ADDENDUM NO. 1

Reference: Heat Trainer Building ó Camp Williams
Utah National Guard ó Draper, Utah

Project No. 10243480

Utah National Guard
NEW HEAT TRAINER BUILDING
Camp Williams, Utah
DFCM Project No. 10243480

SITE PLAN
 1"=10'-0"

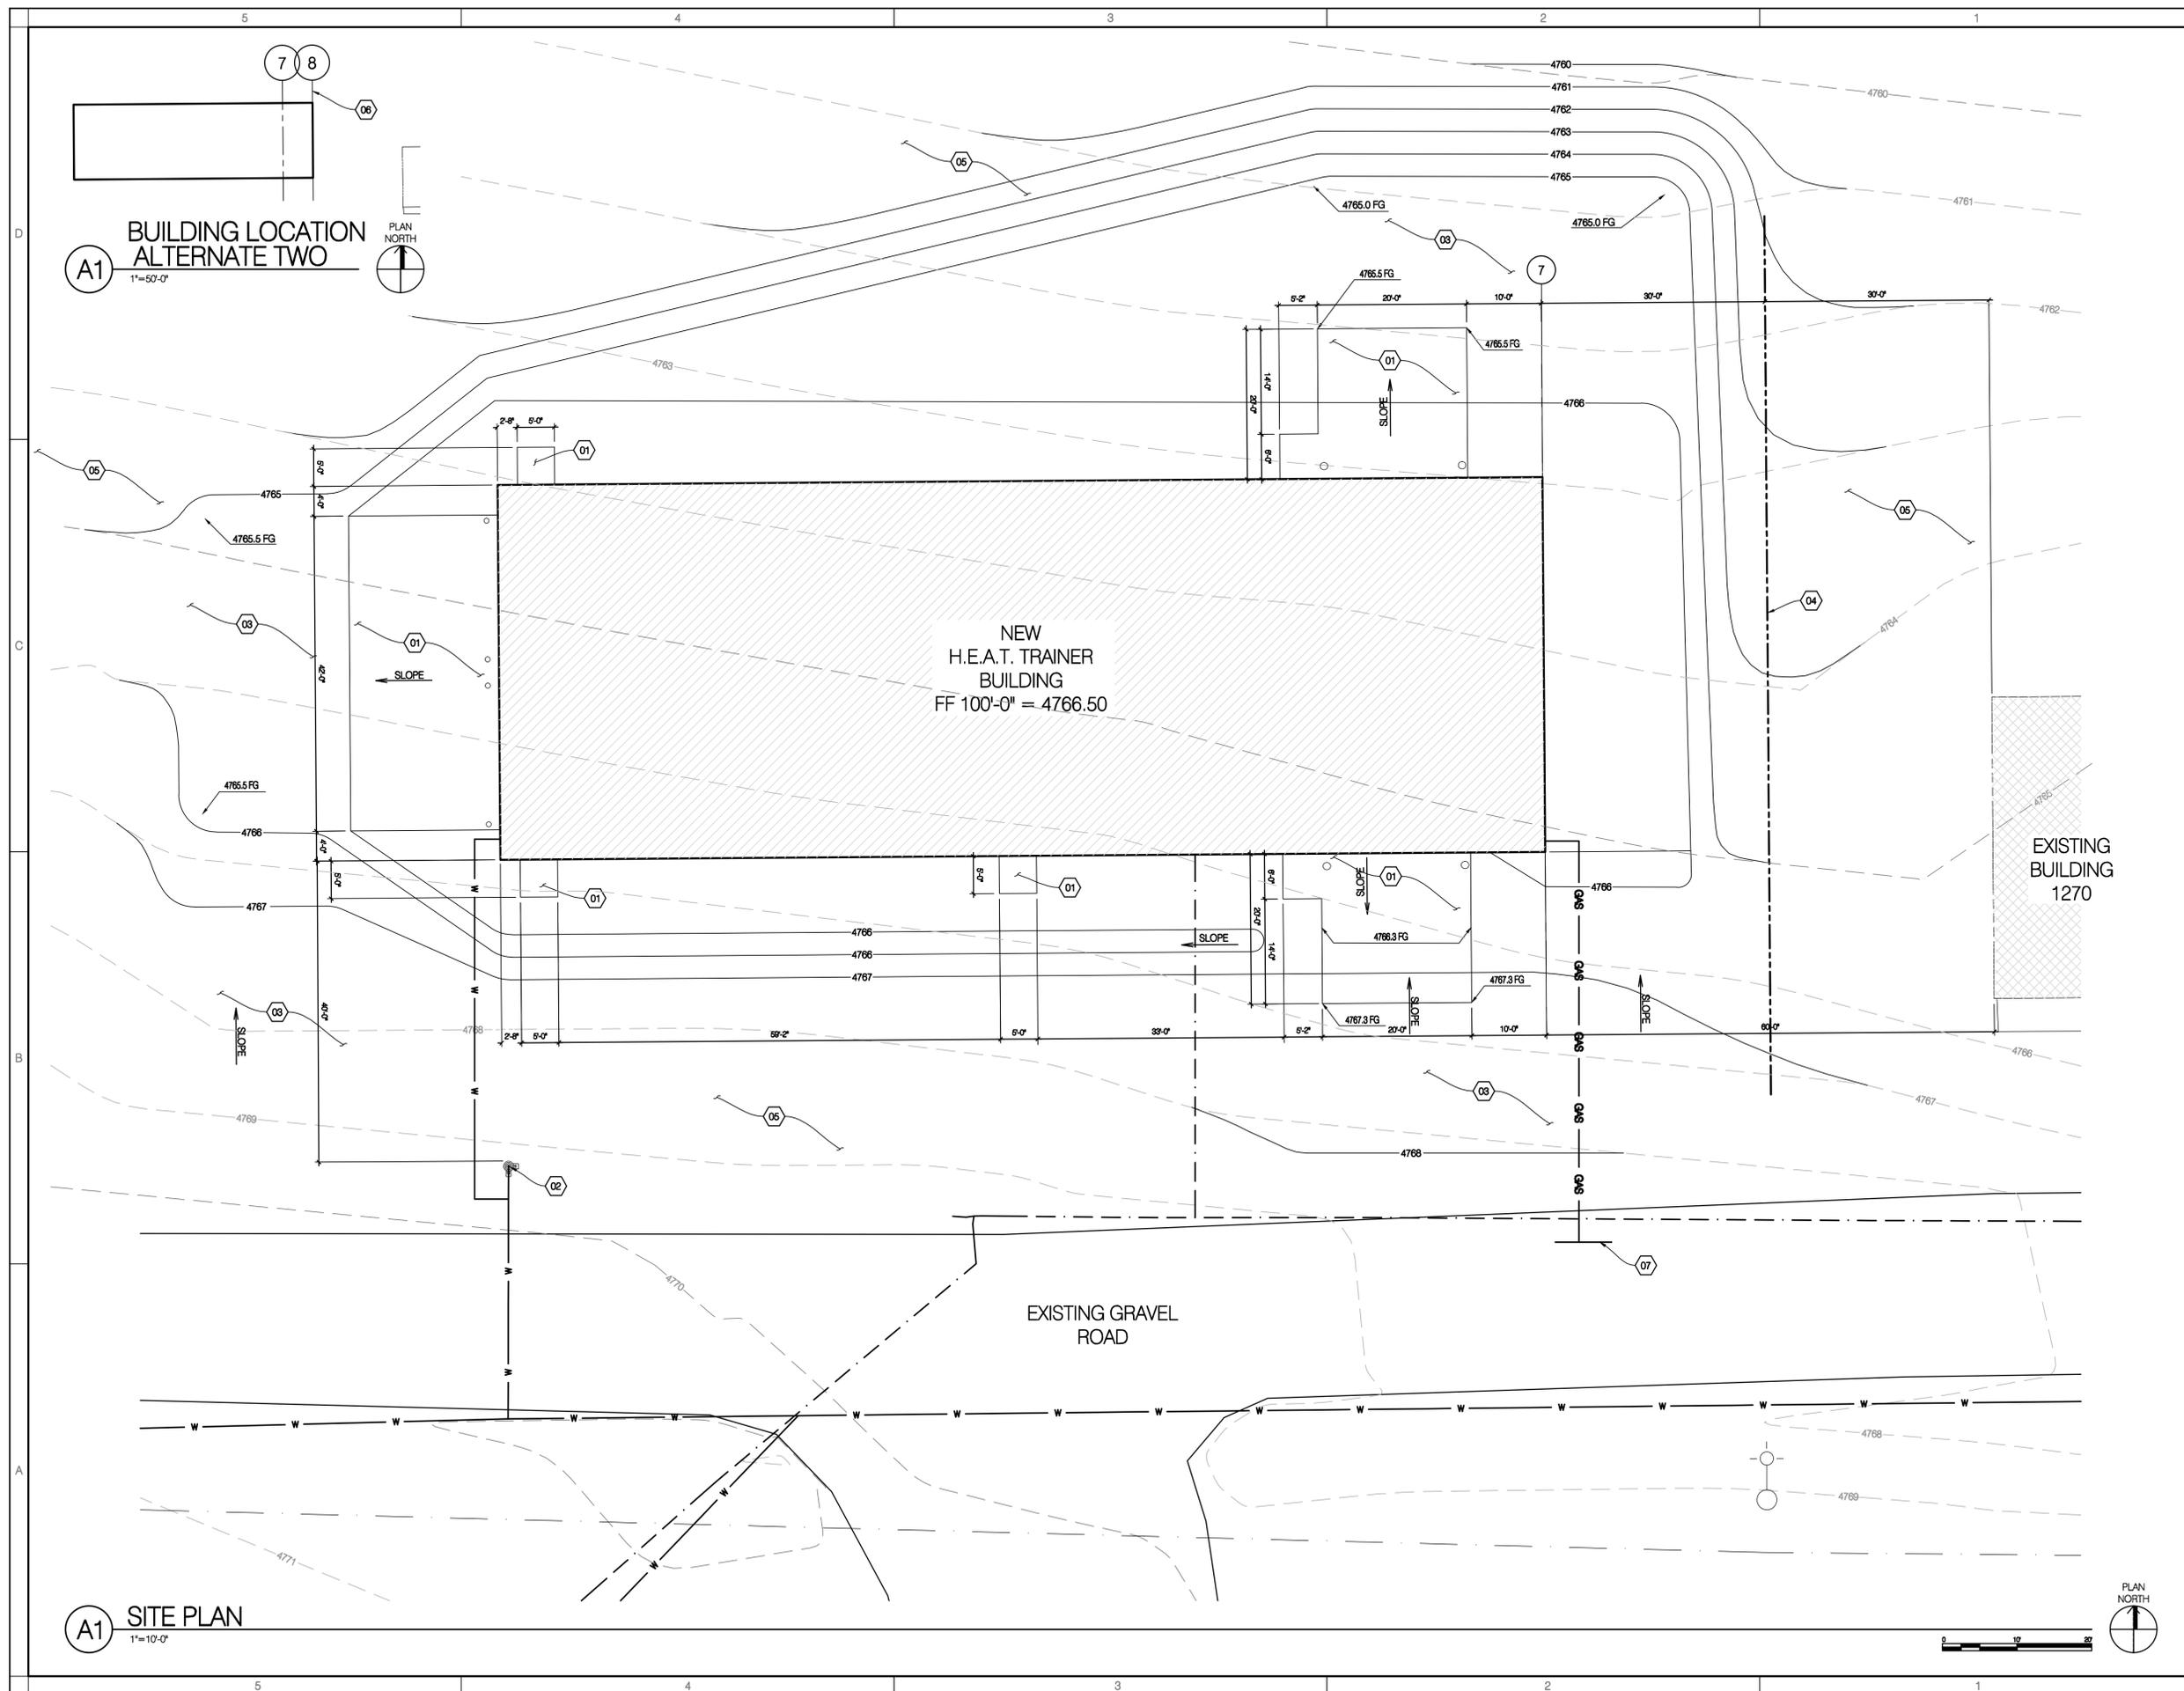
1. CONCRETE SLAB - SEE AE101 - SEE STRUCTURAL
2. EXISTING FIRE HYDRANT
3. GRADE SITE TO PROVIDE 20' MINIMUM ROADWAY TO BUILDING APPROACH SLABS.
4. ASSUMED PROPERTY LINE
5. GRAVEL SURFACING
6. LOCATE GRID 8 IN ALTERNATE TWO IN THE SAME LOCATION AS GRID 7 IS IN THE BASE.
7. VERIFY LOCATION OF THE GAS LINE

C4 FOOTING & FOUNDATION PLAN - MEZZANINE
 SB101 SCALE: 1/8"=1'-0"

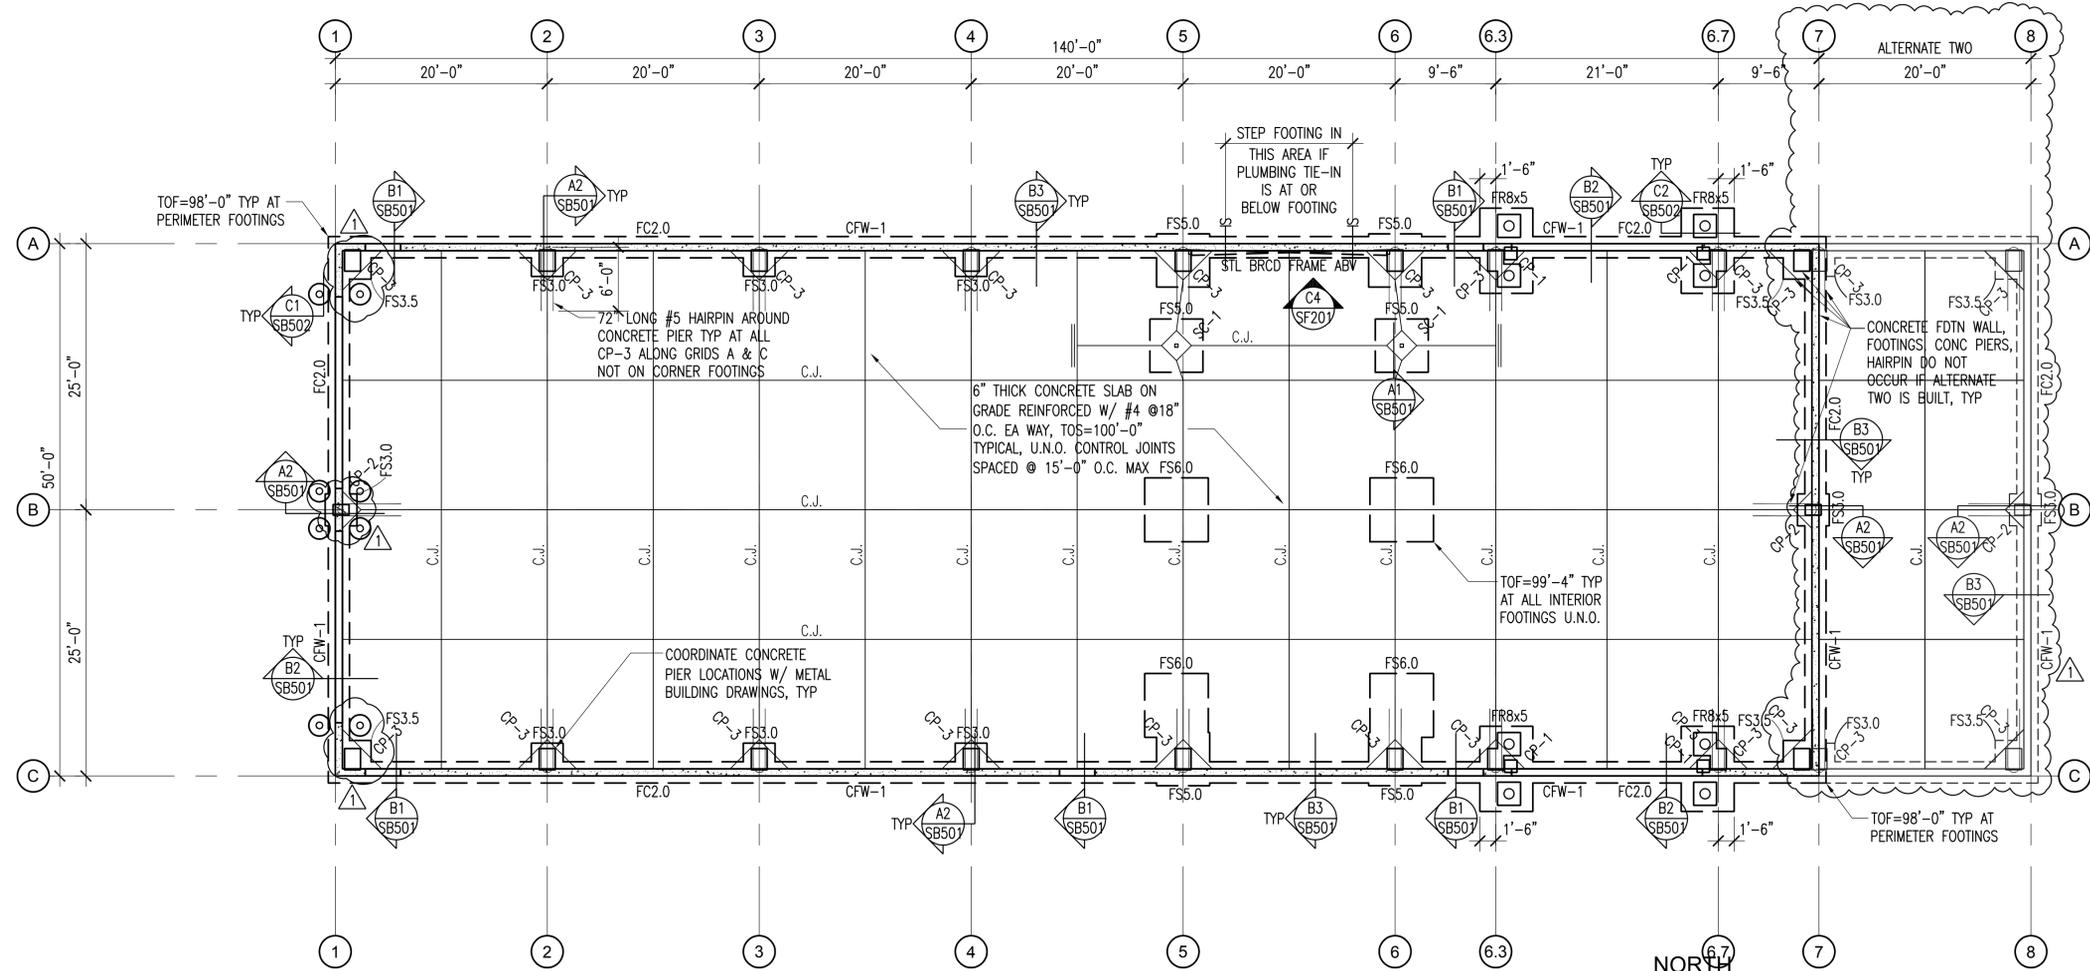
1. Sheet SB101. Detail A3/SB101. Added Alternate Two at Grids 7 and 8.
 2. Sheet SB101. Detail C3/SB101. Detail name modified to clarify alternate number.
 3. Detail SB101. C3 and C4. Footing and foundation plan, and framing plan added.
 4. Sheet SB501. Modified length of pipe foam insulation from 1'-6" to 1'-0."
-
1. Sheet M-101:
 - a. Added UH-4 for alternate # 2.
 - i. See attached sketch SD-1
 - b. Added Keyed note 14 for alternate #2.
 - i. See attached sketch SD-2
 - c. Rotated F-1 and F-2 and added supply/return duct to units.
 - i. See attached sketch SD-8
 2. Sheet M-601:
 - a. Increased size of Unit Heaters, added UH-4.
 - i. See attached sketch SD-3
 3. Sheet P-101:
 - a. Sized gas line and added UH-4.
 - i. See attached sketch SD-4,SD-5,SD-6
 - b. Added gas isometric.
 - i. See attached sketch SD-7.

ELECTRICAL SITE PLAN
 ES102 SCALE: 1" = 60'-0"

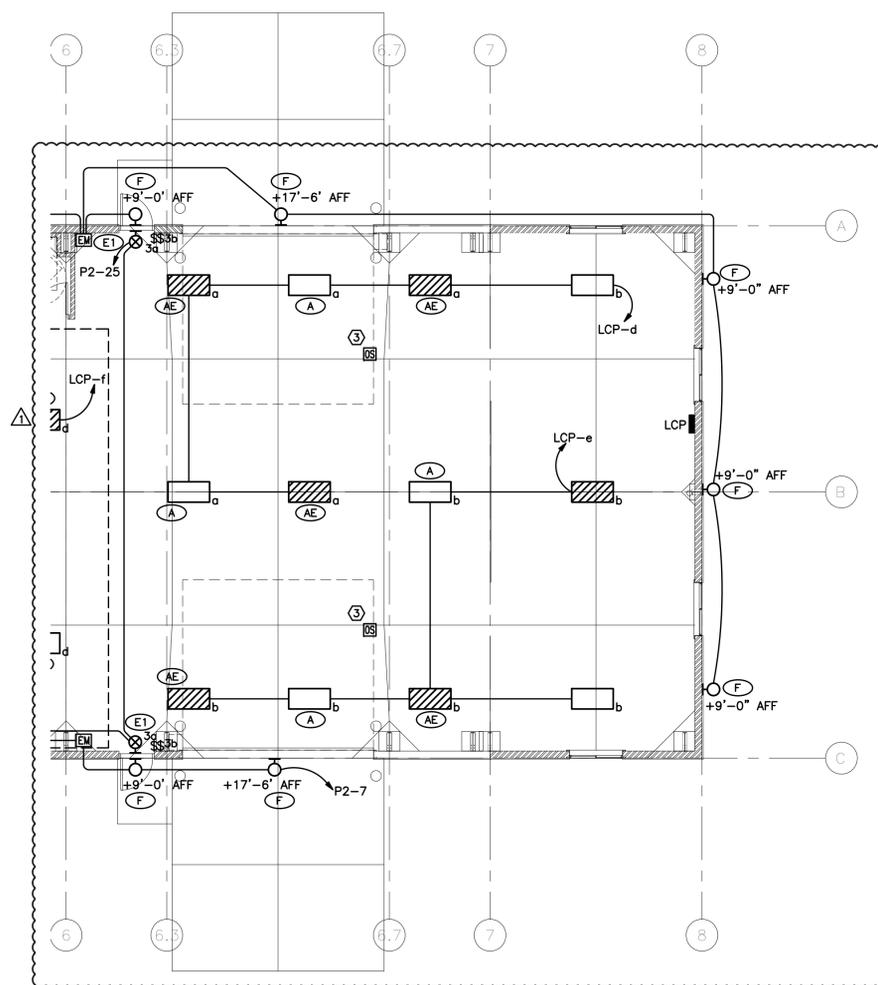
9. Sheet ES102. Add Sheet ES102 to show the fiber path from building 6170 to the new simulator building.
10. Sheet EL101. Move the switch at the top of the mezzanine railing to be on the wall at the bottom of the stairs in the alternate 1 plans.

1 ELECTRICAL LIGHTING PLAN - ALTERNATE #2
 EL102 SCALE: 1/8"=1'-0"

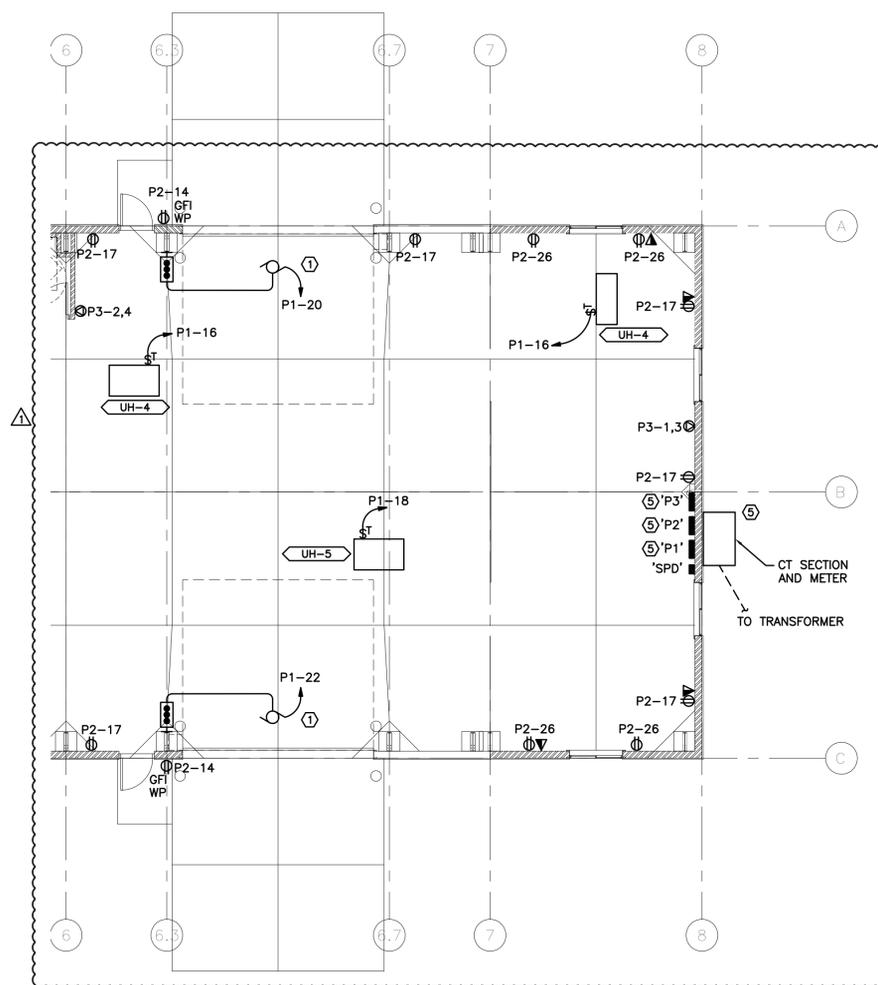
13. Sheet EL102. Add attached sheet EL102 to show alternate 2 lighting for the building expansion.

1 ELECTRICAL POWER PLAN - ALTERNATE #2
 EP102 SCALE: 1/8"=1'-0"

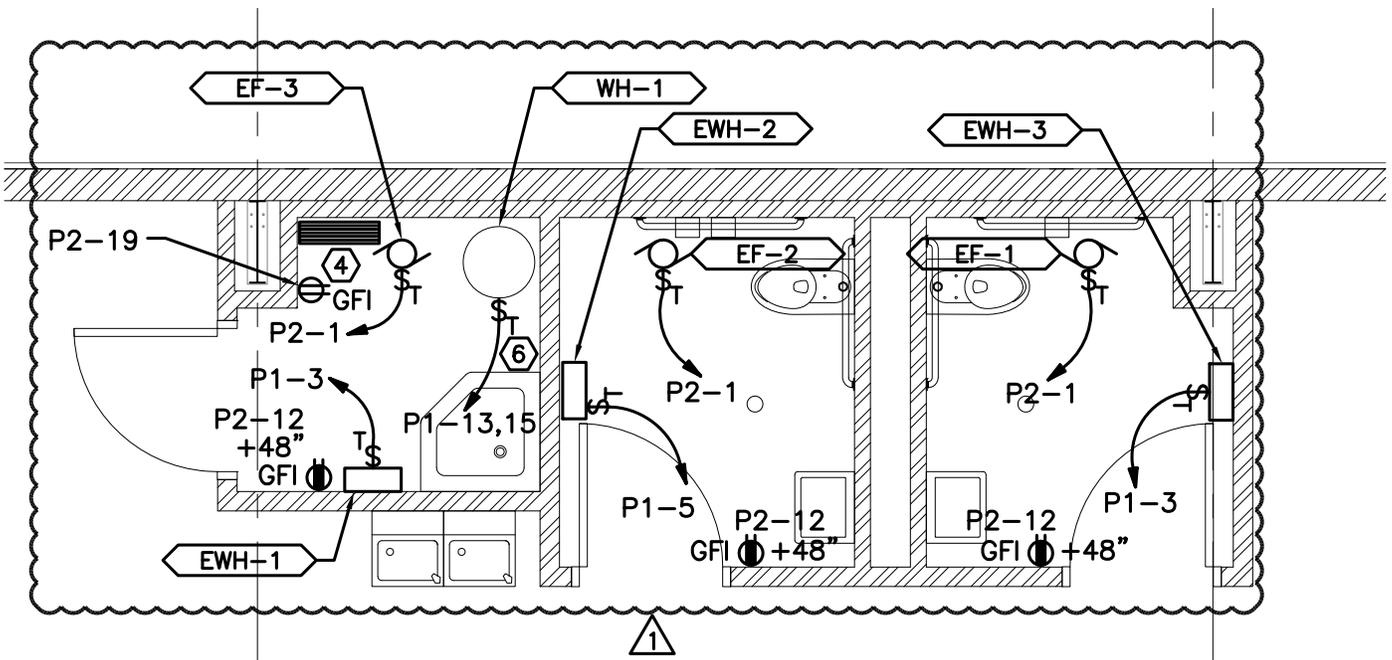
23. Sheet EP101. Delete unit heaterUH-5.
24. Sheet EP101. Add (1)
25. Sheet EP102. Add attached sheet EP102 to show alternate 2 power for the building expansion.

MECHANICAL PLAN - FIRST LEVEL

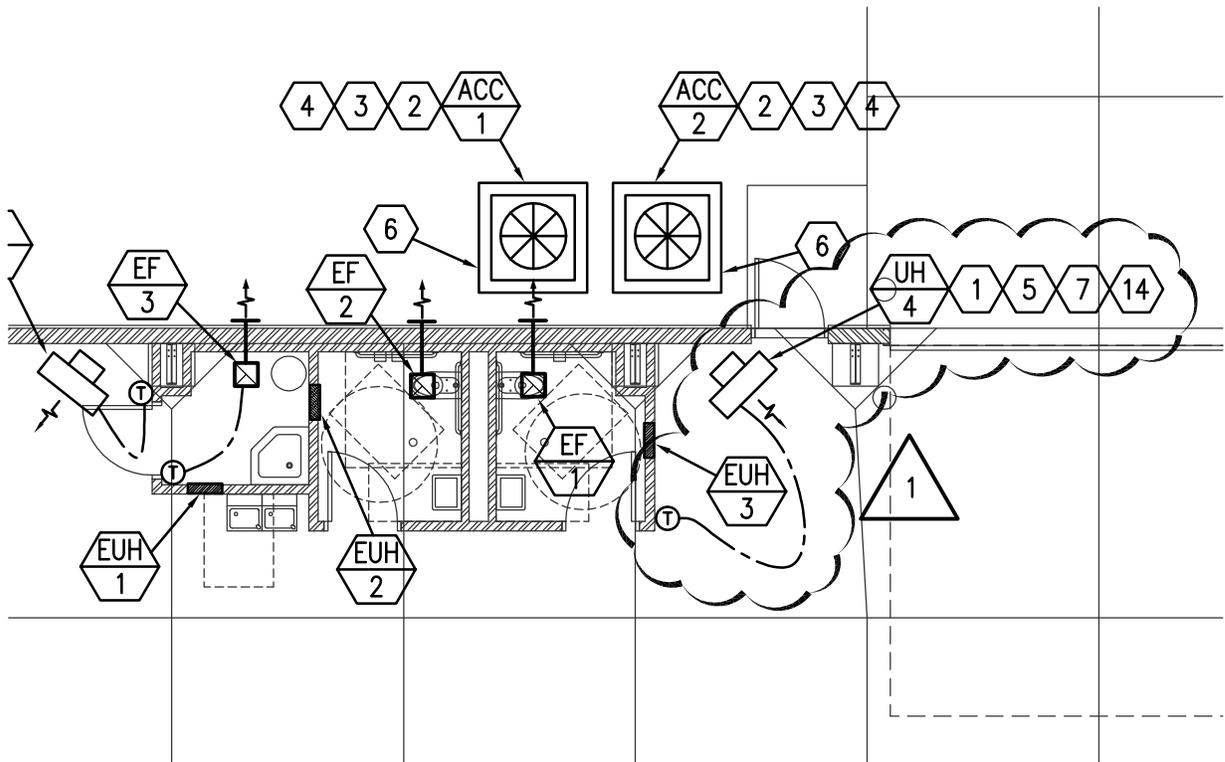
14. FOR BID ALT #2 MOVE UH-3 EAST 20'-0" AND ADD UH-4.

**SD-01
M-101**

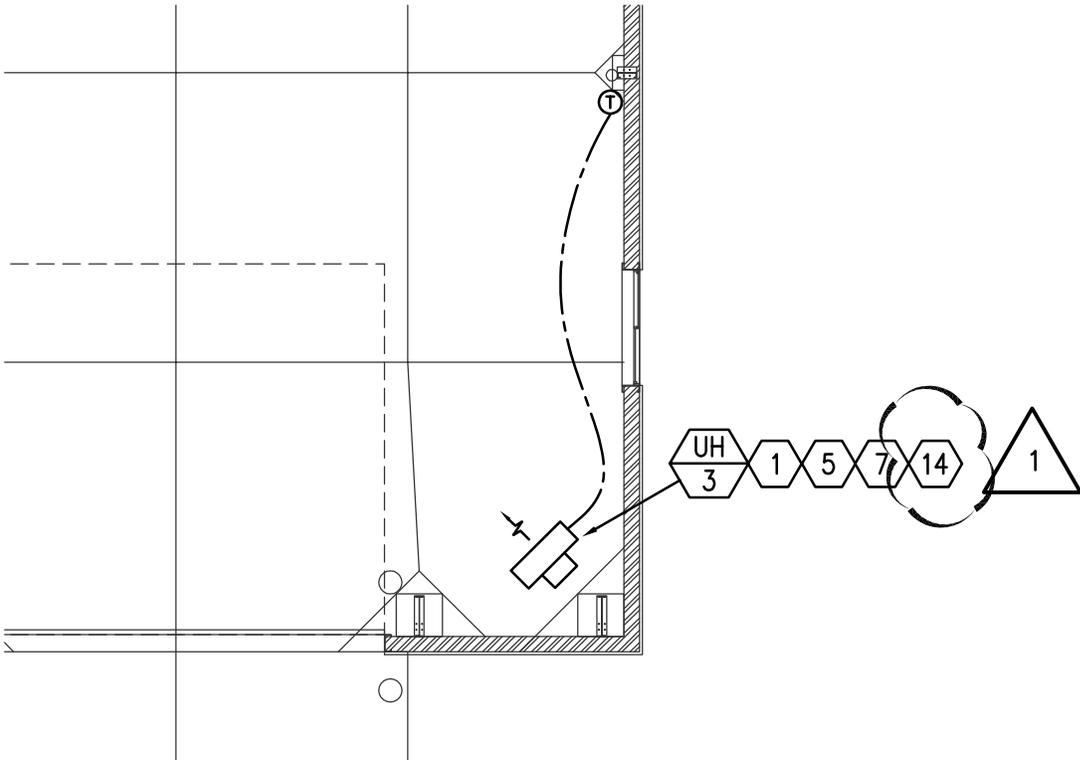
14. FOR BID ALT #2 MOVE UH-3 EAST 20'-0" AND ADD UH-4.

ALTERNATE ENLARGED PLUMBING PLAN

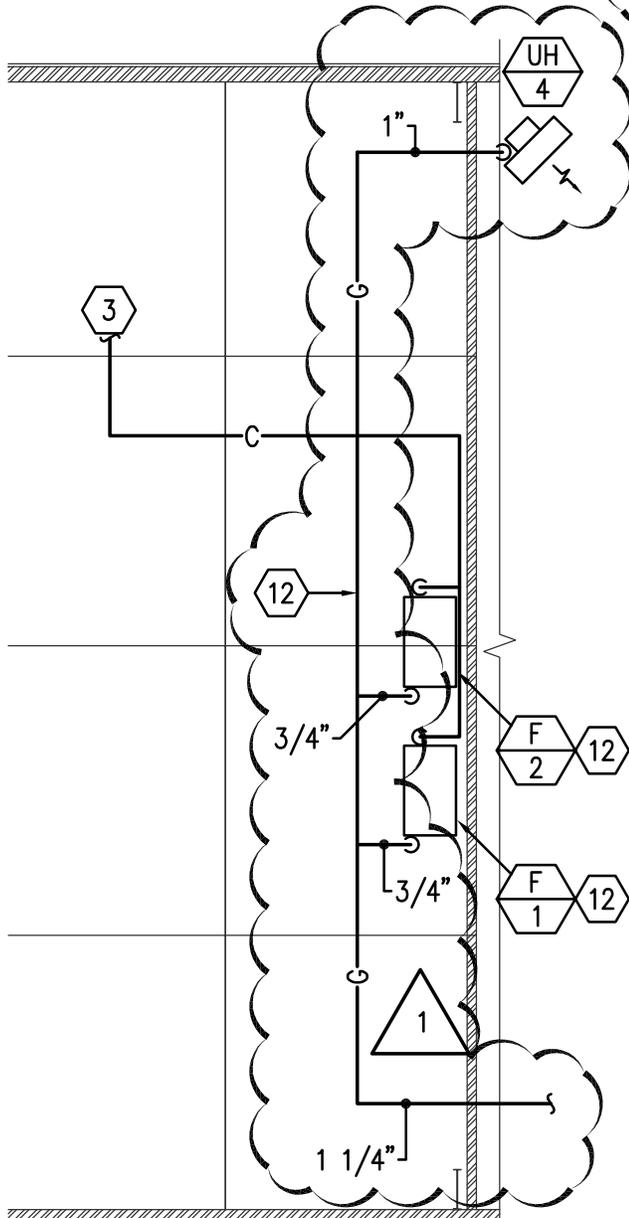
1. SEE ALTERNATE MEZZANINE PLAN FOR GAS PIPING TO F-1, F-2 AND UH-4.
